APPENDIX C
TECHNICAL SUBMISISSONS RECEIVED FROM SUBCONSULTANTS

RE: NANASIVIK MINE CLOSURE AND RESTORATION

RE: NANISIVIK A&R PLAN ROCK MECHANICS REVIEW

RE: **Technical review of CanZinco Ltd's Nanisivik Mine Closure and Reclamation Plan, RGC Project No. 089005/1**

Figure 1. Total Cd Concentrations at Select Monitoring Locations

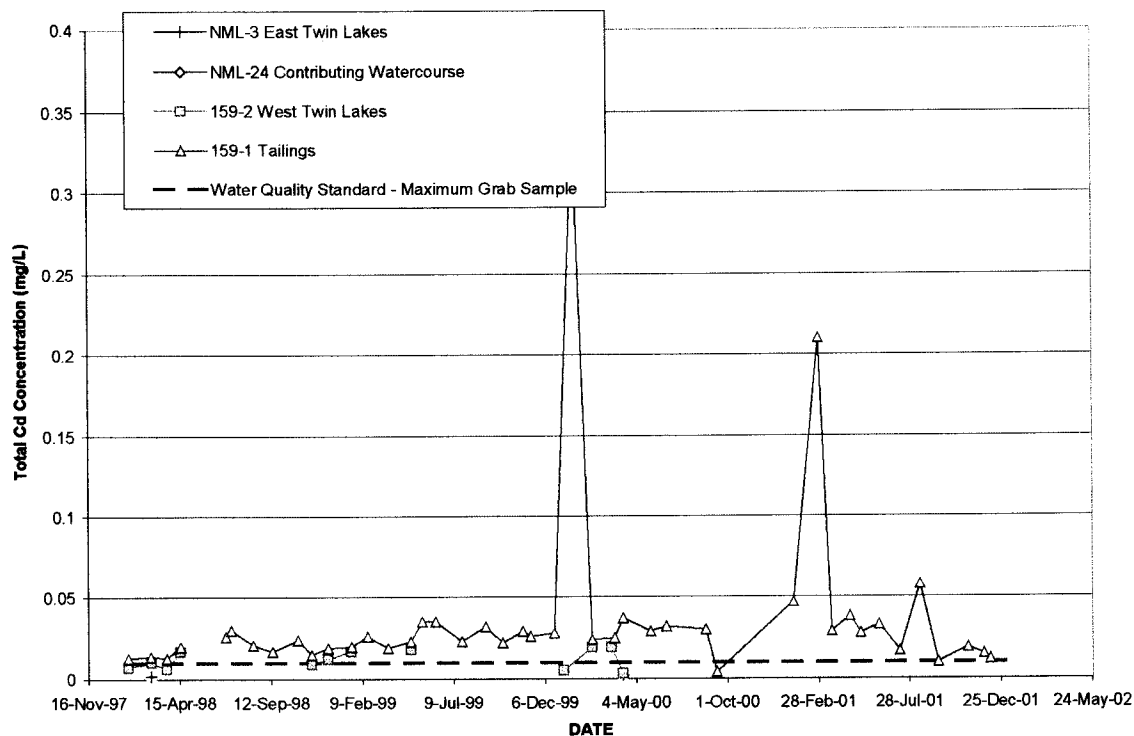
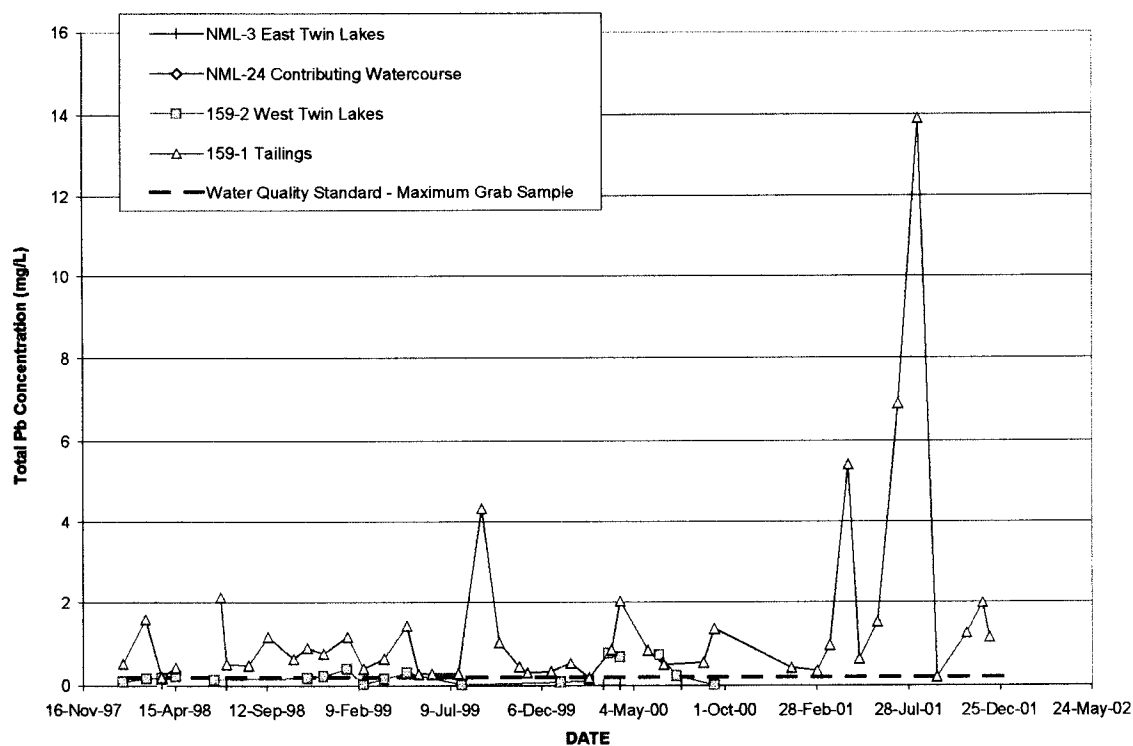
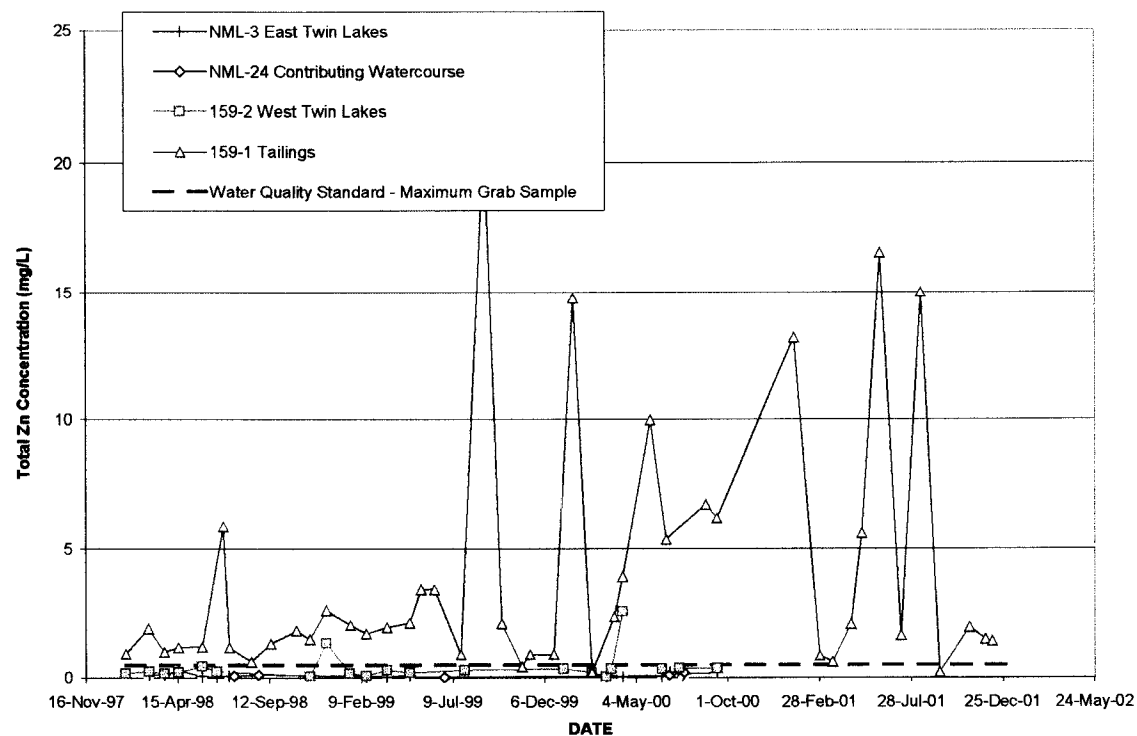
The acid base accounting results and water quality results (sample location 159-1) suggest the tailings are currently buffered, however are considered potentially acid generating with very high sulfur contents. The pH has been maintained alkaline due to process waters and tailings disposal, however concentrations of those parameters reported (Cd, Pb and Zn) are high and consistently above the water quality standards outlined in the Water License (see Figures 1 to 3 below). While attenuation mechanisms and precipitation along the seepage flowpath may reduce the concentrations, Zn in particular may remain relatively mobile at near neutral pH conditions and pose water quality concerns regardless of whether or not acidic conditions prevail in the seepage quality. There was no discussion of metal leaching potential at near neutral conditions found in the documents reviewed. However, if the tailings pore waters freeze completely as is anticipated by CanZinco and their consultants for the sub-aerial tailings, seepage of metal rich waters will likely not result.

The geochemical characteristics of the shale identified as cover material indicate that the shale is acid consuming. It will not generate acid itself and does contain excess buffering capacity, however it should be noted that it will not be an effective buffering source for acid generating material underlying it, but will only provide neutralization for acidic waters in direct contact with the shale (i.e. seepage migrating through it) as the acidic solutions dissolve the carbonate buffering minerals. In this case, it would be anticipated that significant secondary mineral formation, such as gypsum ($\text{CaSO}_4 \cdot 2\text{H}_2\text{O}$, a white 'salt'), would be evident due to anticipated high SO_4 in acidic waters and Ca from the shale itself. This mineral formation has been noted in the dyke shale during geotechnical inspections in a number of the documents reviewed, suggesting SO_4 -rich seepage through the dyke is or has occurred.

Figure 4. Total Zinc Concentration for Select Monitoring Stations (smaller Y axis scale).

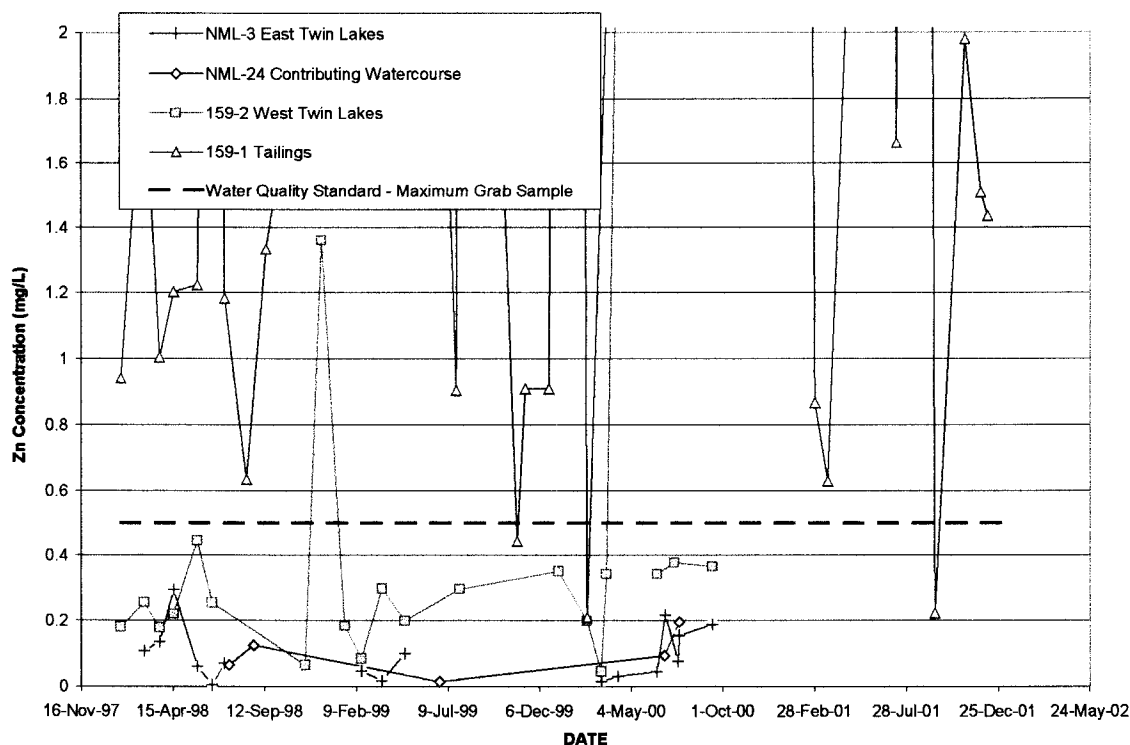
A hydraulic confinement study was undertaken to assess the potential for seepage from the WTDA towards the East Twin Lake. Figure 4 is the same plot as shown in Figure 3 with a smaller Y-axis scale to look more closely at the results from those locations with smaller Zn concentrations.

No definitive increase in Zn concentrations is seen in East Twin Lakes since early 1998. It would be expected that Zn would be an early indication of contamination as concentrations in the tailings

process waters are elevated. Typically SO_4 concentrations are also tracked in this manner as an early ARD indicator. Adding SO_4 to the parameter list for routine analyses at the locations included in the reclamation and closure monitoring programs would be recommended for these purposes.
